Committee of Experts on the Transport of Dangerous Goods and on the Globally Harmonized System of Classification and Labelling of Chemicals

Sub-Committee of Experts on the Transport of Dangerous Goods

Proposed changes to the Koenen test specifications

Transmitted by the experts from the United Kingdom of Great Britain and Northern Ireland, and the United States of America*

Figure A12.2.1: Burst pressure apparatus setup

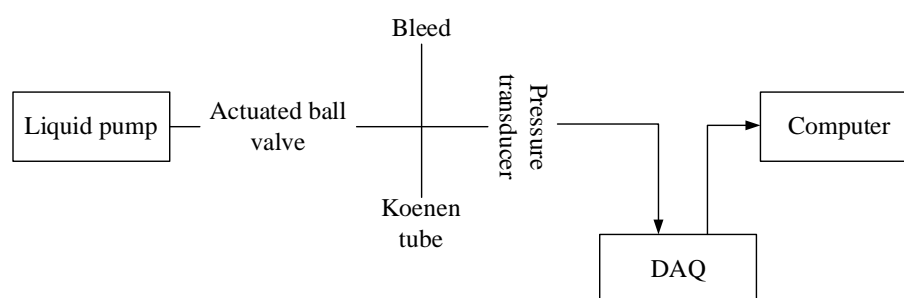
- (a) Burst pressure apparatus (figure A12.2.1) designed to completely purge Koenen tubes of all air and apply pressures of 35 MPa or greater using a non-corrosive liquid. The apparatus is equipped to accept a pressure transducer;

A12.2.3.1 The burst pressure testing apparatus is set up to purge air from the tube and introduce the test liquid. The pressure transducer and data acquisition system are attached (see figure A12.1) and tested to verify proper functioning and capability to accurately measure and record pressures above the maximum burst pressures specified in 11.5.1.2.1 (d), 12.5.1.2.1 (d), 18.6.1.2.1 (d) or 25.4.1.2.1 (d) of this *Manual*.

A12.2.3.2 The Koenen tube is labelled and inserted into the threaded collar with the modified orifice plate on top of the tube, then the collar nut is tightened to provide an effective seal.

A12.2.3.3 The modified orifice plate is connected to the burst pressure apparatus and placed in a protective area, then connections verified against leaks. The entire system is purged of air, then the vacuum valve is closed and examined for constant pressure. The actuated ball-valve is closed to prevent premature pressurization of the Koenen tube, after which the supply line to the closed valve is charged with the pump to approximately 35 MPa. The ball-valve is opened remotely and gauge pressure at which tube bursts is recorded.
